NOTICE OF MEETING
PLANNING AND ZONING COMMISSION
6:00 P.M. – May 12th, 2022
30360 Cougar Bend, Bulverde, TX 78163

PLANNING AND ZONING COMMISSION ITEM:
PC-22-11
FINAL PLAT
BULVERDE RV PARK

PLANNING AND ZONING COMMISSION ITEM:
PC-22-12

SUBJECT: Goldsmith Phase I
Preliminary Plat Review
PC-22-12

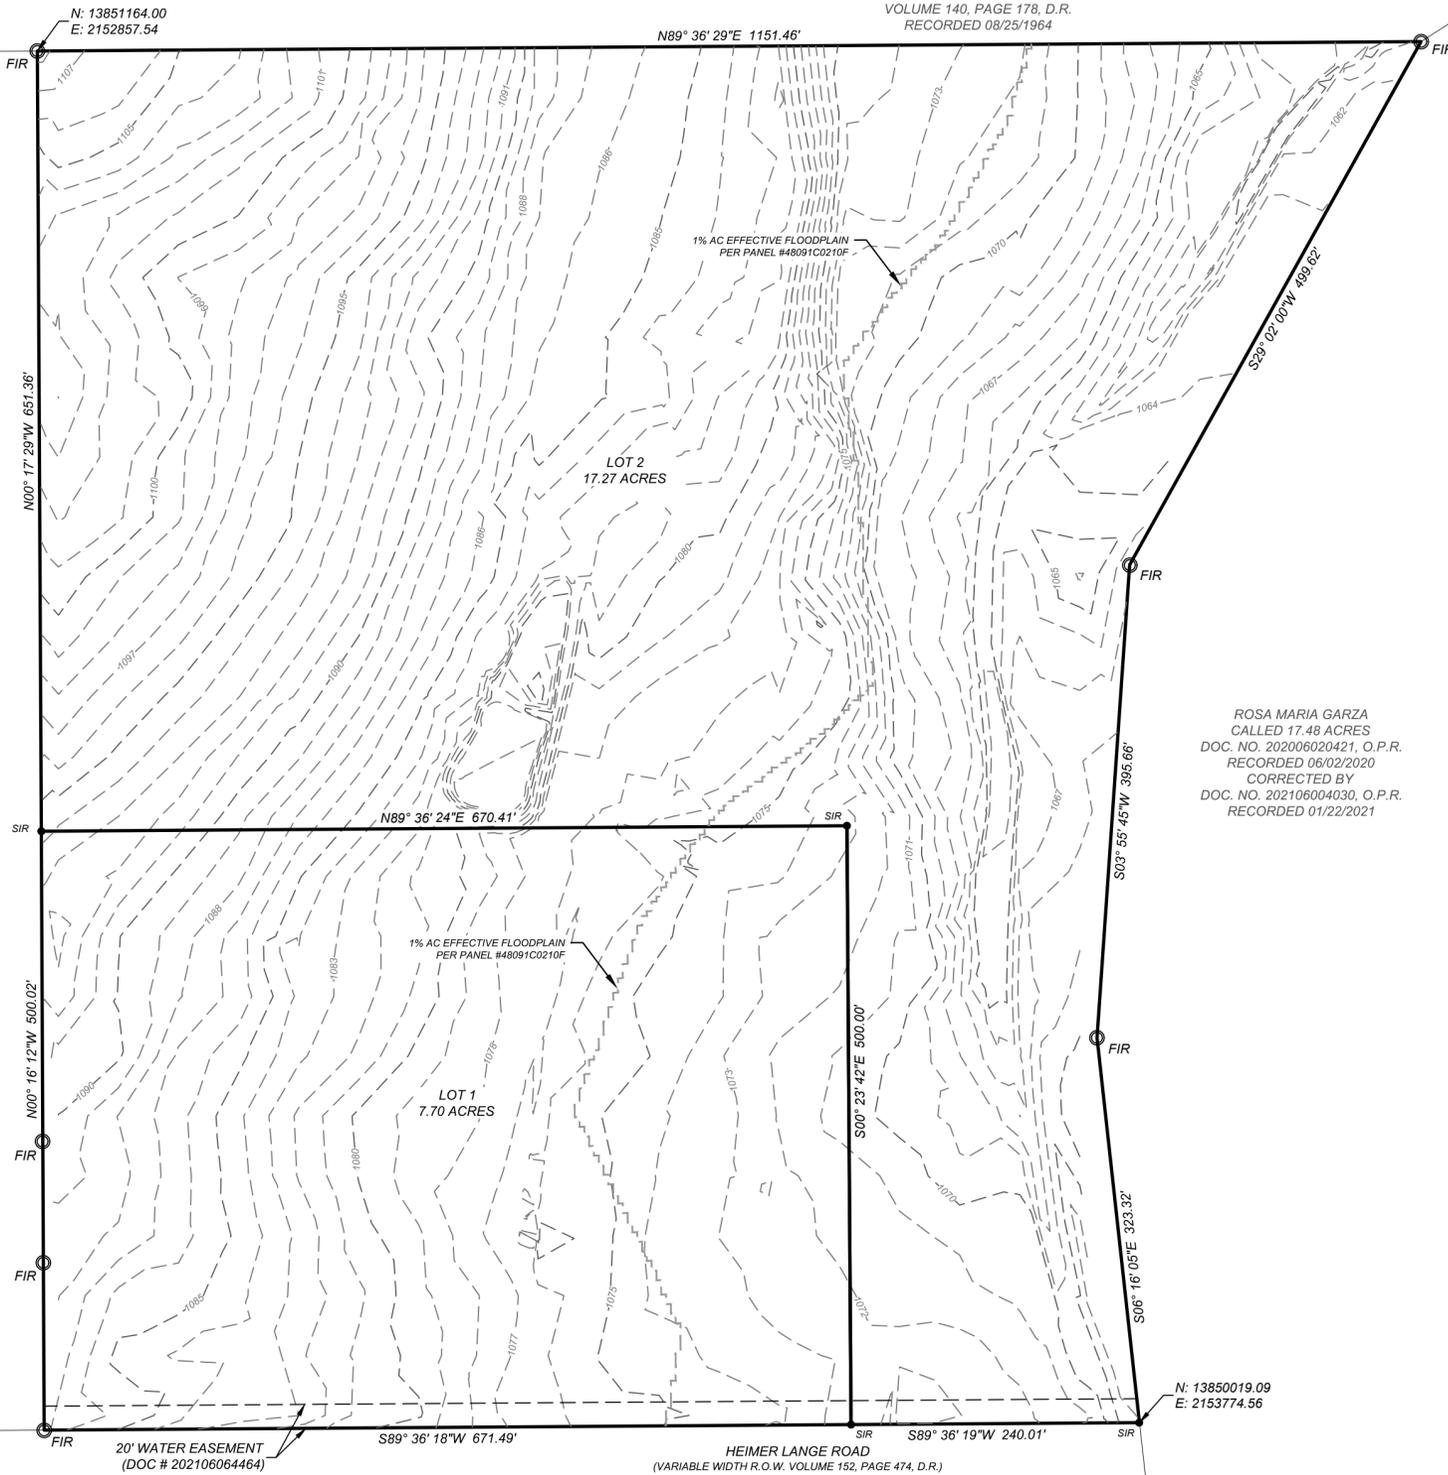
1. Plat should be labeled "Subdivision Plat" not "Development Plat."
2. Provide Lienholder address and certification on plat.
3. Provide Planning Director signature block similar to:

4. Provide County Clerk signature block similar to:
5. Label lots with "Lot 1, Block 1" and "Lot 2, Block 2."

6. Provide bearing and distance dimension from a corner of the subdivision to a corner of the original tract or original survey.
7. Building setback lines must be shown per section 2.03(c) of the subdivision ordinance.
8. Show City limits lines on vicinity map and plat.
9. Plat Note #2 states that there is no FEMA floodplain on-site. Correct this.
10. Surveyor Note #5 should reference Comal County.
11. Provide Slope Map and any applicable easements required by Section 1.05(b)(ii)(24) and Section 4.04.
12. Add note to plat stating maximum impervious cover, matching TCEQ approval letter.
13. Access easement required if the only point of access for Lot 2 is through Lot 1.

14. Are there any existing wells on-site? If so, they need to be indicated on the plan and marked to be plugged.
15. Provide dimensions clarifying spacing between water/sewer lines.
16. Show approximate electric site layout.
17. Water Service required to each newly created lot. Currently Lot 2 only has water service from the internal private line.
18. Provide Water Study showing waterline configuration meets domestic and fire flow needs for entire site.
19. Fire Hydrants required throughout site to provide coverage to RV slots throughout development.
20. Provide Sewer/OSSF information. Confirm density of 153 units + amenity building is serviceable with OSSF on 24.97 acres.
21. Note: Underground OSSF facilities not permitted within FEMA Floodplain.

22. Per chapter 7 of the Bulverde Drainage Manual, on-site detention shall be provided for runoff control from new development. The peak-on-peak analysis submitted is not adequate justify not meeting this requirement. You must show that providing detention will cause adverse impacts to off-site property or be under the 2,000 square feet of new impervious cover specified in the BDM.
23. Provide calculations required to determine size and location of drainage easements to convey upstream runoff from the adjacent property (west) through the subject property.
24. Provide existing and proposed impervious cover information on site exhibit.
25. Provide C-value calculations in drainage area maps.
26. Use C-values provided in Bulverde Drainage manual (see Bulverde Drainage Manual table 4.2) or provide C-value calculations in report.

27. Describe existing structures within project area. If no structures are present, please state in project summary.
28. Include a Stormwater Pollution Prevention Plan (SWPPP) with final plat submittal (see chapter 10 of the Bulverde Drainage Manual).

35. More detail needed for final cost projections (i.e. approximate total length of utility lines, approx. pavement quantity).

- 20-ft entrance driveway width is not adequate for a 2-way commercial driveway with large RV vehicles.
- Provide site dimensions and radii to verify fire lane through property.
- Provide Tree/Site overlay plan with tree protection, mitigation and removal noted. A general note referring the contractor to the owner prior to tree removal is not adequate. The City must approve any tree removals (reference Section 4.06 of subdivision ordinance).
- Grading plan required

SUBMITTAL DATE: APRIL 12, 2022
PRINT/REVISION DATE: -
MHE JOB NO. - 3219.01
MHS JOB NO. - 21-4025
SHEET 2 OF 7

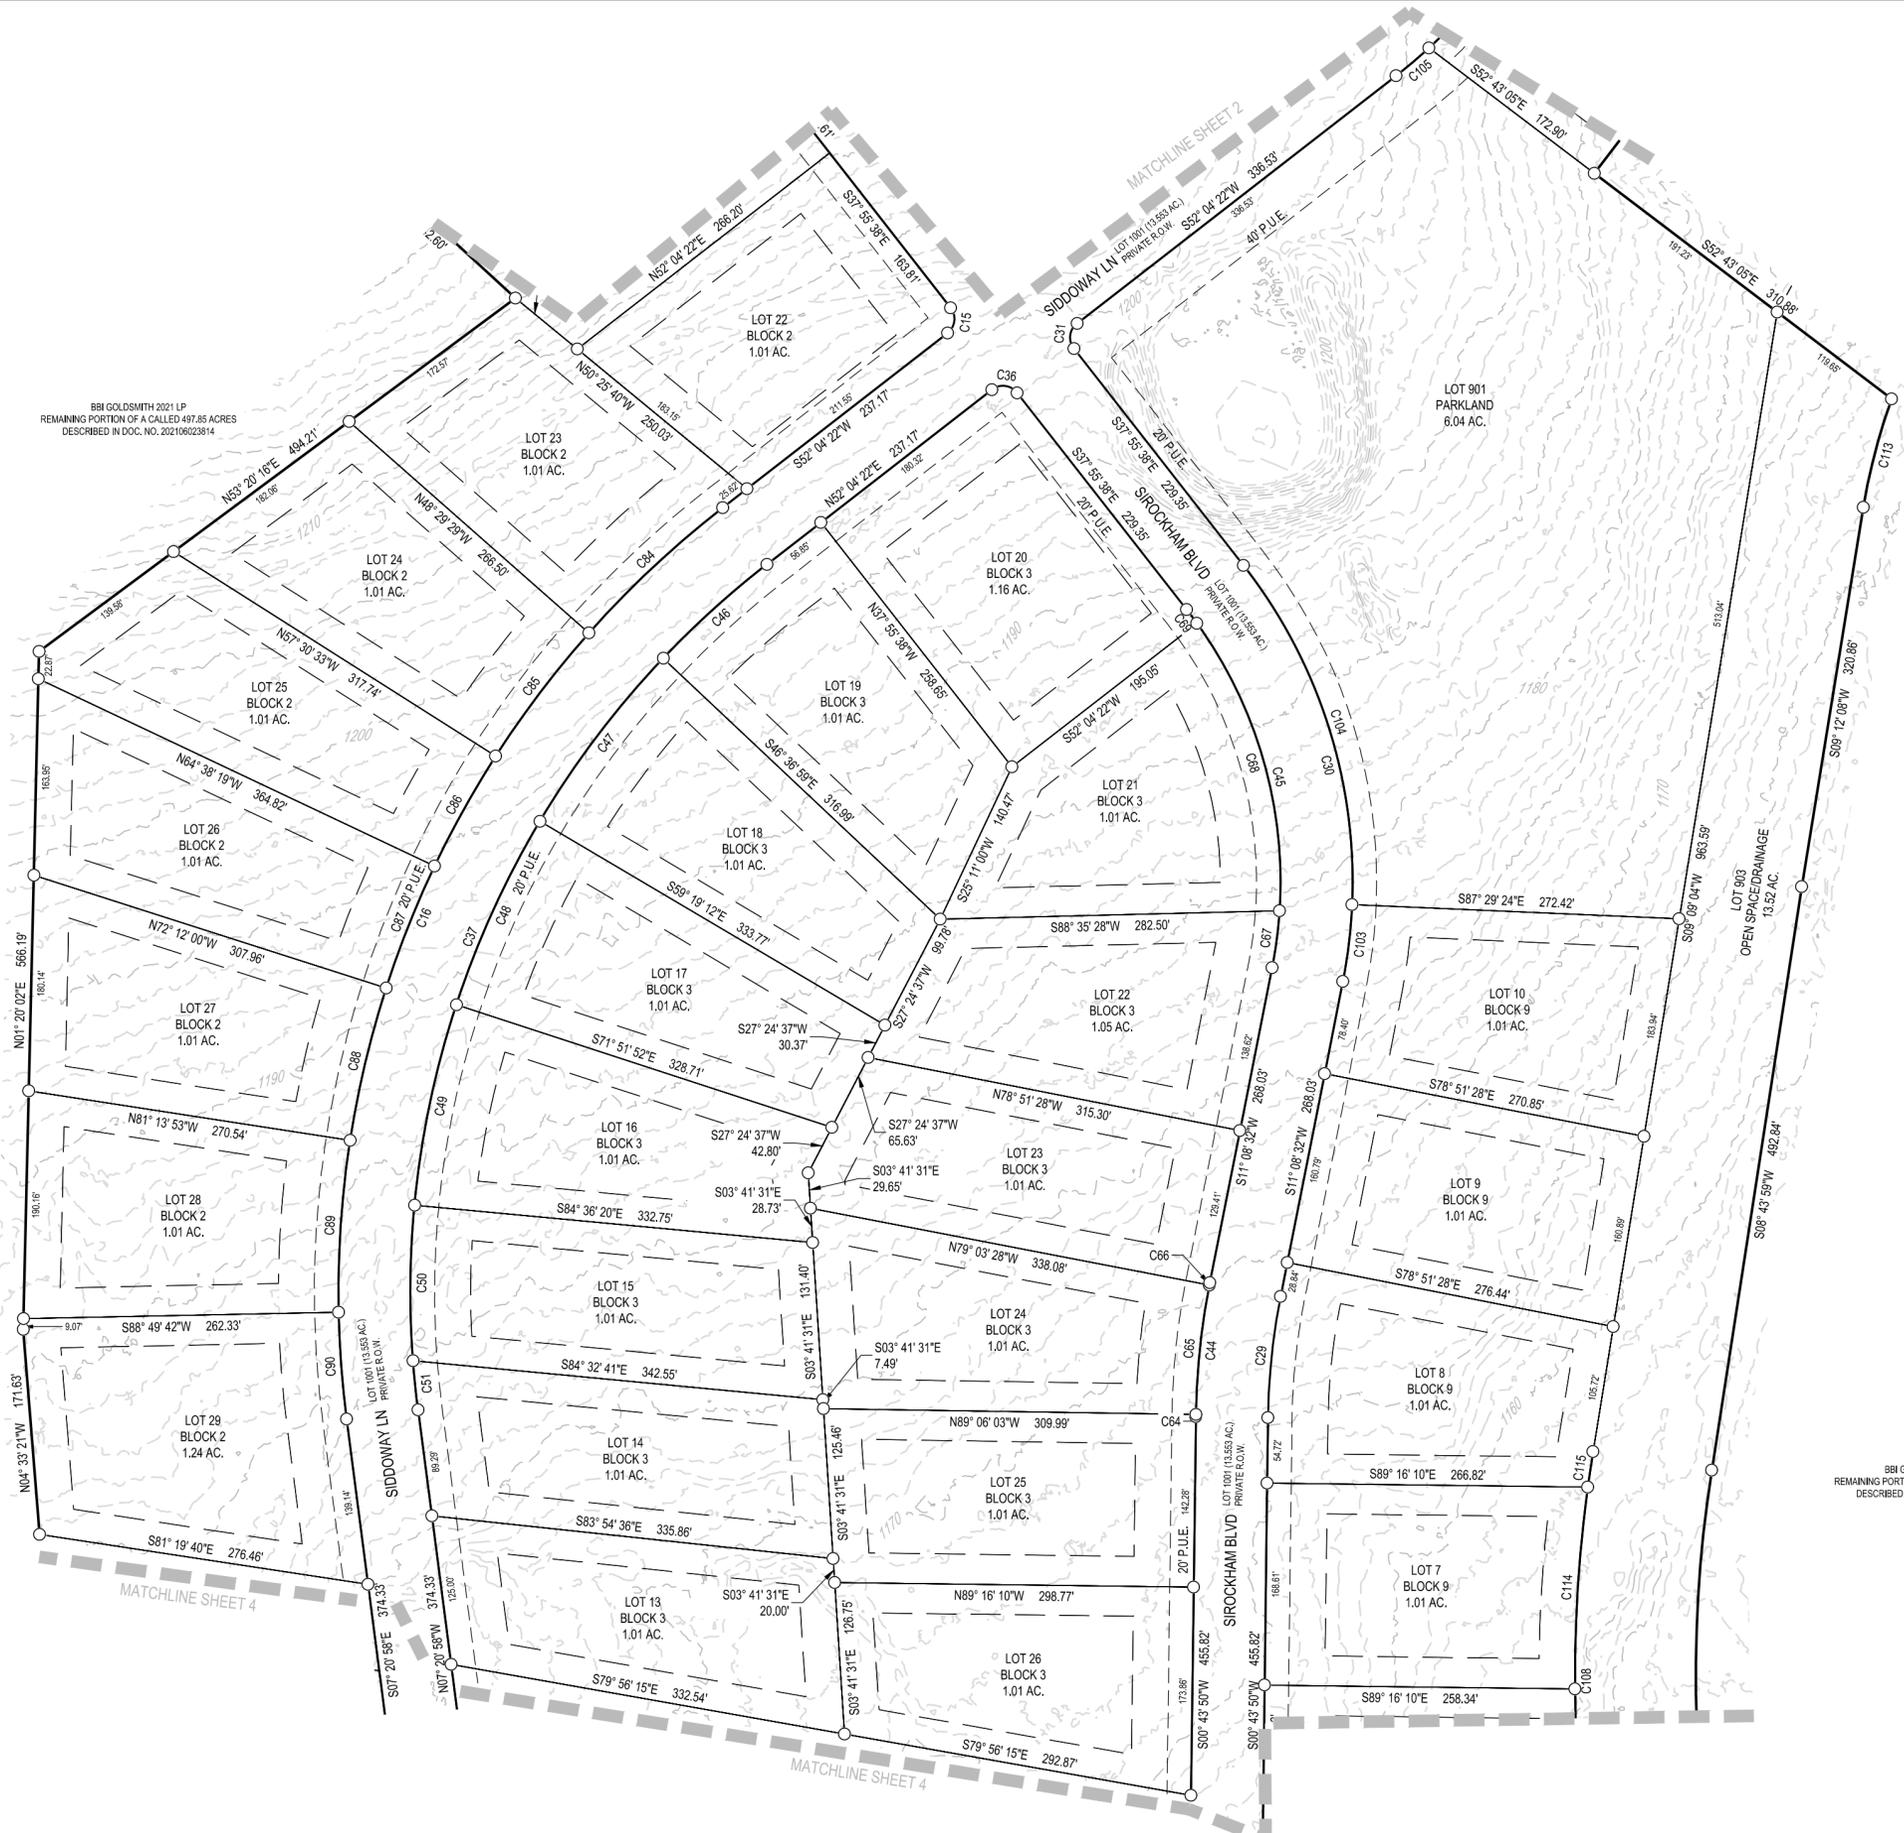
10. Correct adjacent property information on sheet 2 of 7, adjacent to lots 35, 36, 43 & 44. This appears to be Centennial Ridge Unit 1 (show adjacent lots in dashed linework per Sec.1.05(b)(ii)(20)).

Drainage Analysis:

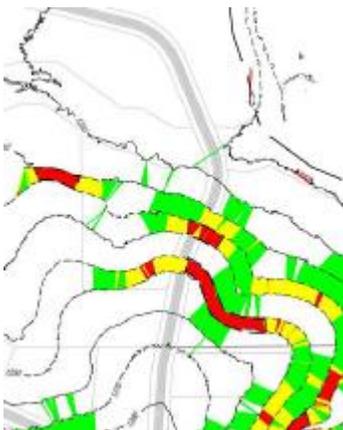
12. Note: Hydraulic analysis of drainage channels will be required at the time of platting to confirm the widths of drainage easements/open space rights-of-way.
13. Provide a Riparian Buffer Conservation Submittal, per Section 4.07(d).
14. Drainage area EX1.1 needs to be broken up to look at the runoff coming directly through and off of the subject development, and not lump it in with the larger overall watershed looking at a downstream point, and allow for a more direct comparison with proposed conditions that includes detention ponds.
15. Curve Number calculations should include the area in acres (not just percentage) for each land use type. Fair Woods and Farmsteads are not uses identified in the BDDM, and curve numbers for these areas need to be updated for all CN calculations.

Slope Map

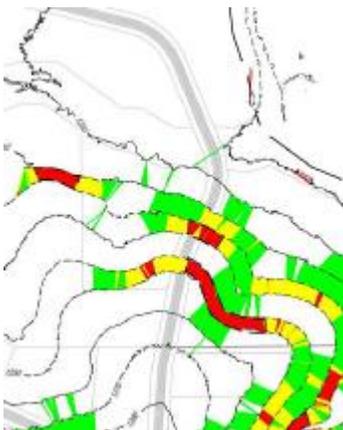
19. Elm Valley Drive’s disturbance of areas with slope greater than 25% appears unavoidable in order to maintain the connection to the existing segment of Elm Valley Drive. However, this portion of Cedar Sage Lane should be adjusted to avoid area with slopes >25%.

20. Summarize the number of acres and the number of acres disturbed by the current road layout within each slope category.
